## HISTORIC AND DESIGN REVIEW COMMISSION

May 07, 2025

**HDRC CASE NO:** 2025-095  
**ADDRESS:** 122 LEOPOLD  
**LEGAL DESCRIPTION:** NCB 2960 BLK 2 LOT 6&7  
**ZONING:** R-6  
**CITY COUNCIL DIST.:** 1  
**APPLICANT:** Elaine Lutton/Lutton Properties LLC  
**OWNER:** Elaine Lutton/LUTTON PROPERTIES LLC  
**TYPE OF WORK:** Construction of two 1-story rear additions  
**APPLICATION RECEIVED:** April 08, 2025  
**60-DAY REVIEW:** June 07, 2025  
**CASE MANAGER:** Bryan Morales

122 LEOPOLD  
SOUTH ELEVATION  
901 V4"

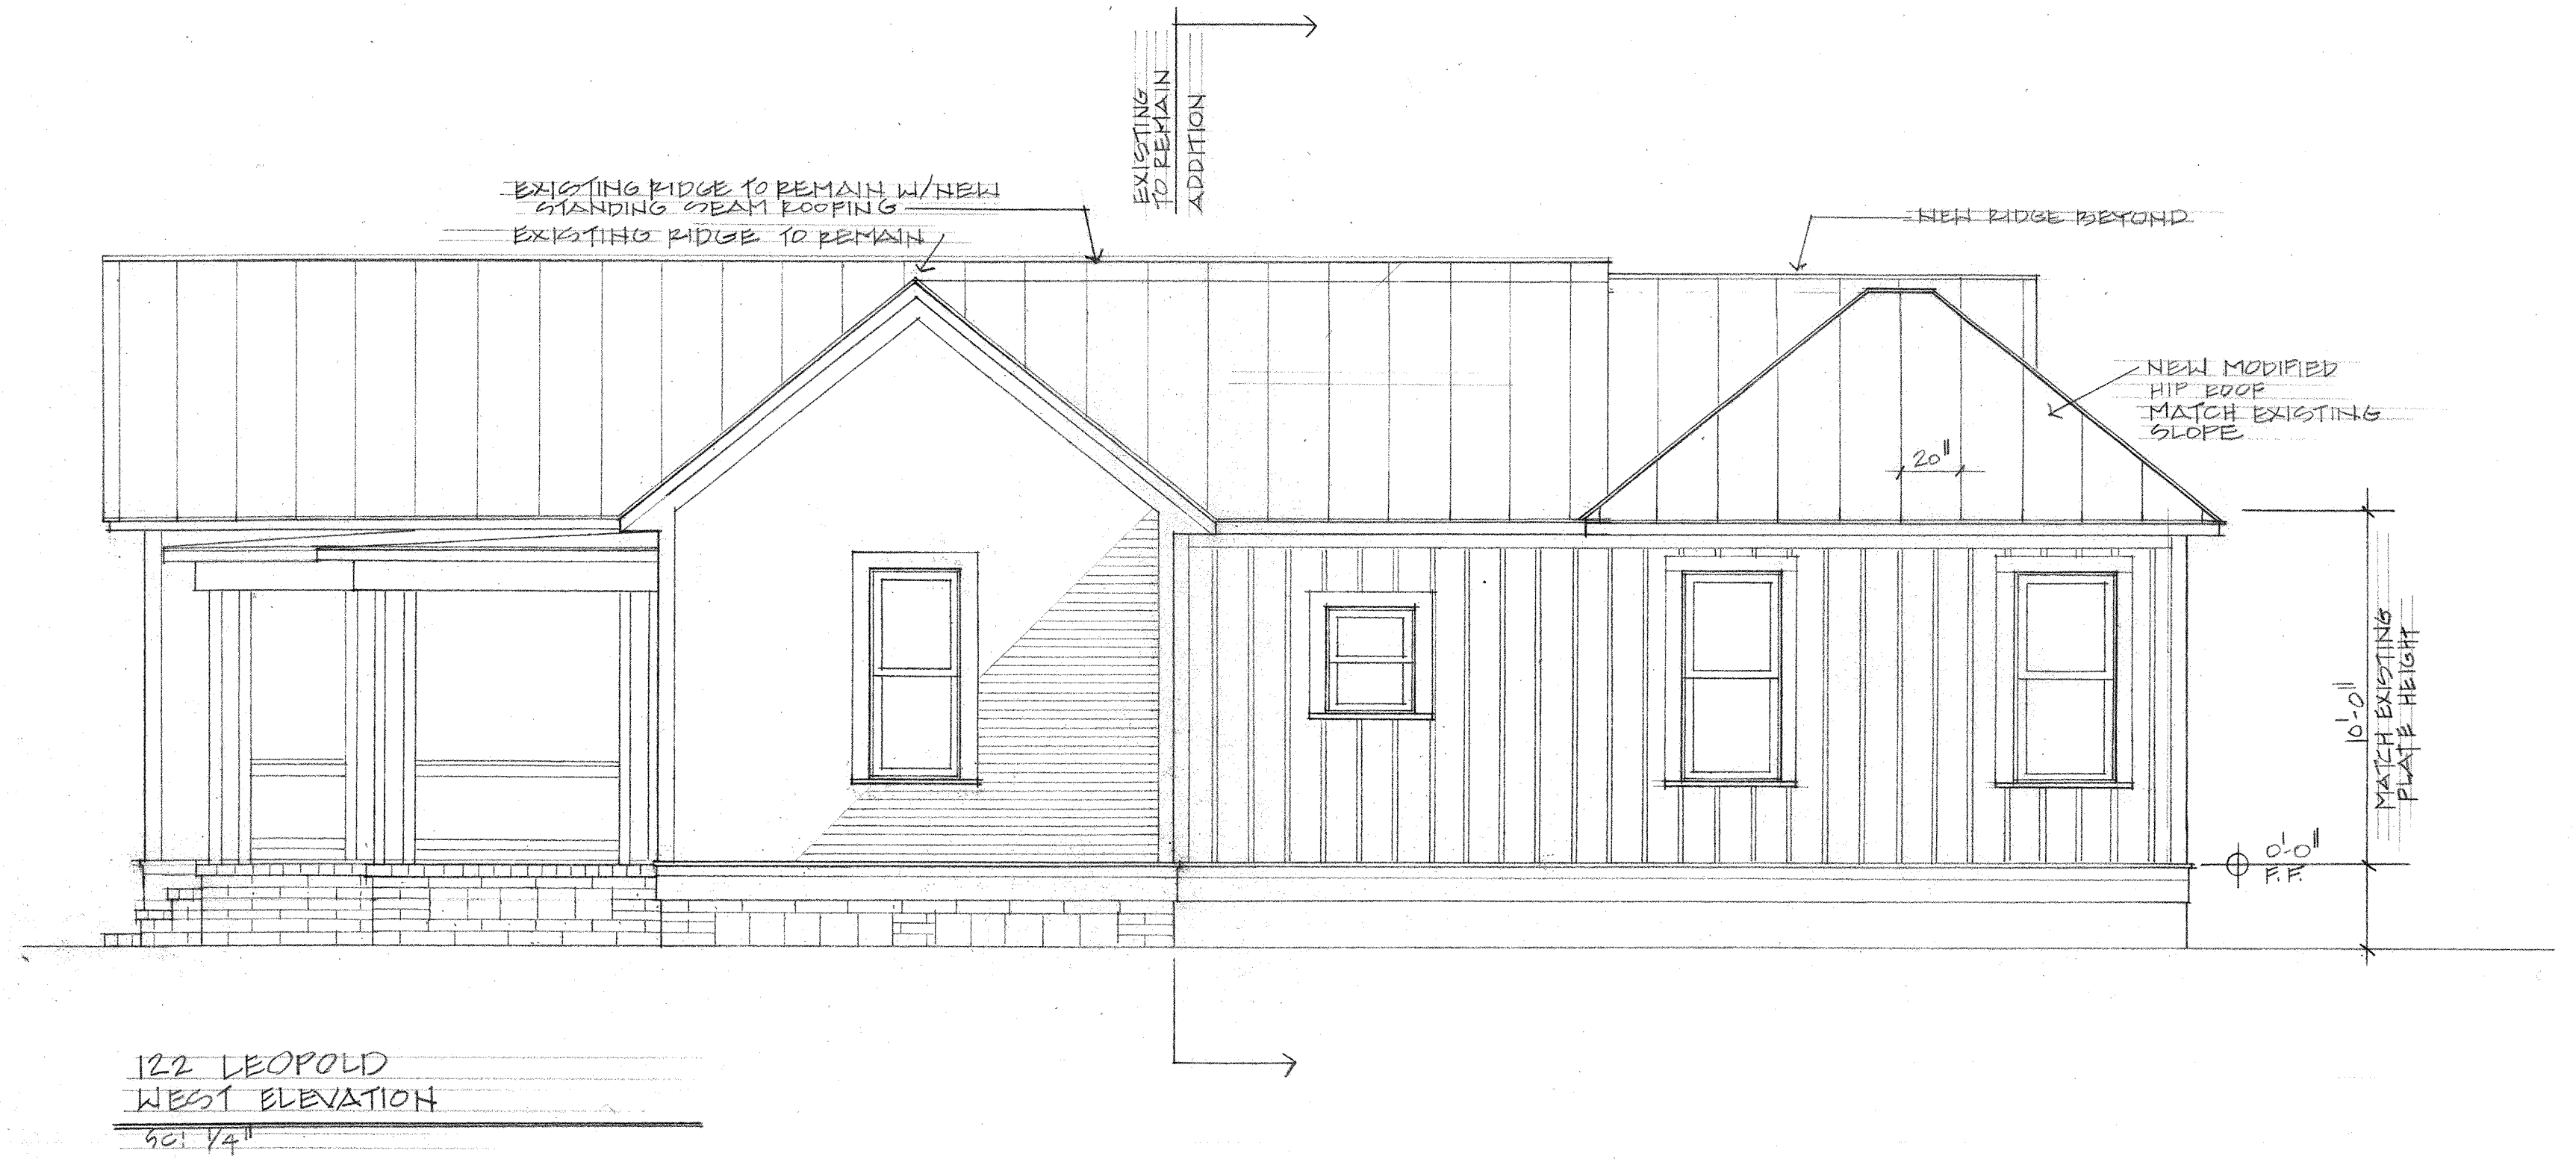
- i. **REAR ADDITION (SOUTHEAST: NEW WINDOWS: SIZE AND PROPORTION)** – The applicant is requesting approval to install two one-over-one windows on the south façade of the southeast addition. The Standard Specifications for Windows in Additions and New Construction clarifies that new windows on additions should relate to the windows of the primary historic structure in terms of materiality and overall appearance. In addition, whole window systems should match the size of historic windows on the property unless otherwise approved and windows should feature traditional dimensions and proportions as found within the district. Staff finds the installation of the proposed windows conforms to Guidelines.

- i. That the board and batten siding features boards that are twelve (12) inches wide with battens that are 1 – ½” wide.
- ii. That the applicant install new or salvaged fully wood or aluminum-clad wood windows that meet staff's standard window stipulations and submits updated specifications to staff for review and approval. The windows should feature an inset of two (2) inches within facades and should feature profiles that are found historically within the immediate vicinity. Meeting rails must be no taller than 1.25” and stiles no wider than 2.25”. White manufacturer's color is not allowed, and color selection must be presented to staff. There should be a minimum of two inches in depth between the front face of the window trim and the front face of the top window sash. This must be accomplished by recessing the window sufficiently within the opening or with the installation of additional window trim to add thickness. Window trim must feature traditional dimensions and architecturally appropriate sill detail. Window track components must be painted to match the window trim or concealed by a wood window screen set within the opening.
